## Bulletin 017/2013

**Subject:** Solenoid valves that are not in use, or in storage may be internally corroded and need to be tested.

# General Equipment Safety Bulletin

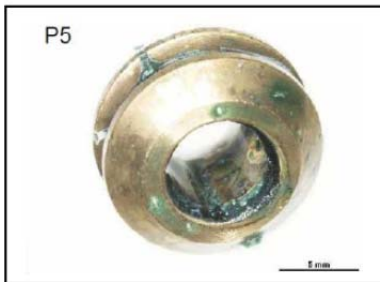
The manufacturer has identified that certain solenoid valves in the affected product range have not been adequately protected from corrosion or deposits while in long term storage [greater than 6 months from manufacture date] prior to use. These valves need to be quarantined from use and returned to Hastings Deering for functional testing.

Corrosion deposits in the valve can lead to increased frictional resistance to movement of the internal parts which could cause malfunction of the solenoid valve if the valve was installed. Malfunction of the solenoid valve may result in unintended or uncontrolled movement of hydraulically-actuated roof support components.

An improved corrosion protection fluid [Quaker Minetech Protection Fluid] has been implemented at the factory on valves with serial numbers after 0496 13 34 16966 and these valves are NOT affected.

If the hydraulic fluid in the valve has been drained out longer than 3 months, [such as in roof supports supplied as components or disassembled components for underground transportation], the valves must be returned to Hastings Deering so correct valve operation can be verified on a test bench. This must be done prior to returning the components or system containing the double solenoid valve to service or further storage.

1. Inspect existing stocks of Longwall double solenoid valves in parts warehouses for applicability to this bulletin.
2. If valves in the affected product serial number and date range are found, return the parts to Hastings Deering for testing and/or replacement. Hastings Deering will provide an exchange valve. Valves found to be faulty will be returned by Hastings Deering to the manufacturer.
